REPORT TO:	Planning Committee	7 th March 2007
AUTHOR/S:	Executive Director / Corporate Manager - Planning and Sustainable Communities

S/6379/06/F - CAMBOURNE

82 Bedroom Care Home, Coffee Shop, 3 Retail Units and Associated Parking and Access at Corner or Monkfield Lane and High Street, Great Cambourne - for Danescroft (Healthcare) Ltd and McA Developments Ltd Recommendation: Approval

Site and Proposal

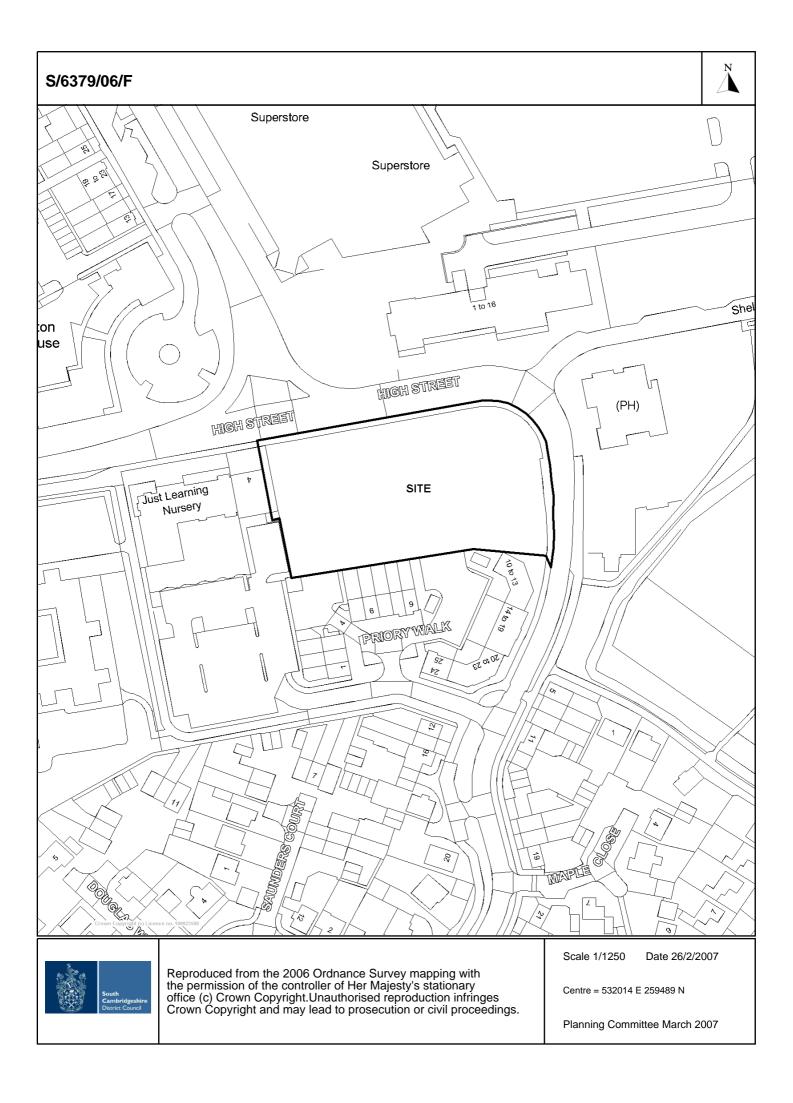
- 8. **Highway Authority -** Original Plans: The footway crossing should be constructed as a heavy duty crossing. The neighbouring fence obstructs a 2.4 x 45m visibility splay to the right.

- 9. Amended plans: It is possible for drivers exiting the proposed site to see 45m to the right from a point 2.4m back from the give way line, although the view is through railings. The angle of sight and the slender rails allow an acceptably safe view, so I will accept the access in its proposed position, as the visibility is reasonable, I therefore withdraw my objection.

- c) Form a positive corner opposite the public house, where the High Street adjoins Monkfield Lane.
- 12. The design involves a substantial 3 storey structure which incorporates significant architectural features at key points, to provide articulation of the elevation and fulfill the townscape functions identified above. It is perhaps unfortunate that this results in the building 'looming' over the veterinary surgery, but this maybe a reflection that the veterinary surgery is too small a scale for a town centre site. Certainly the care home should not be reduced in scale, for to do so would weaken its ability to fulfill the streetscape roles outlined above. The only modification I would suggest to the design is relatively modest, but would, I believe, provide two significant benefits. The modification is to the height of the main roof elements. These roofs have roofs at approx 35 degree pitches, with a flat roof element on top (due to the depth of the building. The change I would like to see would be to reduce the height of these roofs down to the level of the ridge on the element at the extreme west end of the site (adjacent to the veterinary surgery - see marked up elevations). This would produce a simpler, and more elegant roofline in the view down Broad Street and would also lower the ridge lines in relation to the 'rotunda' roof - which needs to be a dominant element in order to fulfill its role in forming the corner. More emphasis might be given to the rotunda roof if a lead covered ball and spike was to be added to its apex. Note, I would not wish to see the pitch of the main roofs lowered, since this would have a detrimental impact on the street enclosure.

- 13. Amended plans: revised elevations have incorporated the changes I requested and greatly improve the overall composition. I am happy to support this revised proposal.

- 15. **SCDC Trees and Landscapes Officer -** Original Plans: More detail of planting and surface treatments needed. Access through planting to (fire?) doors in bedroom 10 needed. Planting needed along the wall separating the residents' garden from the car park.

- 16. Applicants' response to consultations - Security is obviously of concern so the final design will include both passive an active security measures. We are happy to consider the PALO's recommendations about entry control and lighting, but would ask that these be dealt with by condition. In terms of the rear bedrooms 8-12, we will ensure that the external works design creates a semi-private realm as recommended. Regarding the front bedrooms 1-7 a 1m wide margin across the building frontage will remain in the developers' ownership and will be used to create a defensible space through a combination of surface materials, planting and/or railings. The recessed retail frontages will not be removed as they area an integral part of the design theme carried across from the existing commercial buildings nearby to maintain the established urban design pattern, and in any case the combination of isolated columns, shopfront lighting and overhead lighting within the arcaded frontage would minimise risk. The internal security will be addressed as part of the detailed design and specification process in due course and the coffee shop will remain in the ownership and control of the care home operator. We note the highway authority comments and will comply with the requirements.

- 17. The busiest time will be between 10am and 4.30pm when up to 39 staff would be expected to be on duty, of which 10 would be senior management and nursing staff, with the remainder consisting of carers, kitchen, domestic and other support staff. We have amended our drawings to show bin storage proposals for the care home and retail units in more detail, together with refuse vehicle turning. I am happy to incorporate the elevational changes and the drawings are revised accordingly.
